Service Bulletin

Group
1050-54 **No. V₂**

Tools
Spring Bushing
PV 445

Modification of tool SVO 1137 A.

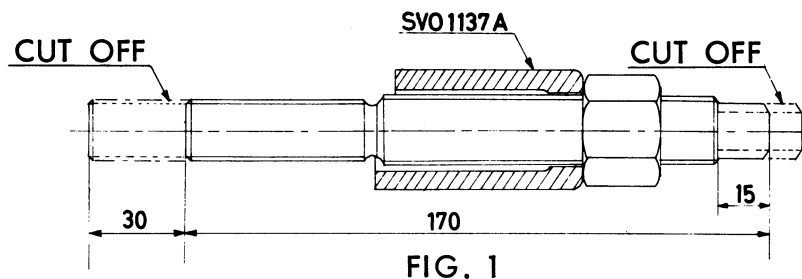
In order to use the above mentioned tool for removing and refitting the bushing in the rear spring bracket of P 44505-07 and -08, the tool must be modified. The modification which is illustrated in fig. 1 means that 30 mm is cut off the shaft from the end which is threaded into the bushing and that 15 mm is cut off the wrench-shank end.

The modified tool will have the designation SVO 1137 B. It is used in the following manner:

When removing, the tool is first screwed into the bushing as per fig. 2. The nut is then tightened up when the bush can be drawn out. When refitting the bushings the tool is inserted in the bracket and screwed together with the loose bushing as per fig. 3. Then the nut is screwed up when the bushing will be drawn into its position.
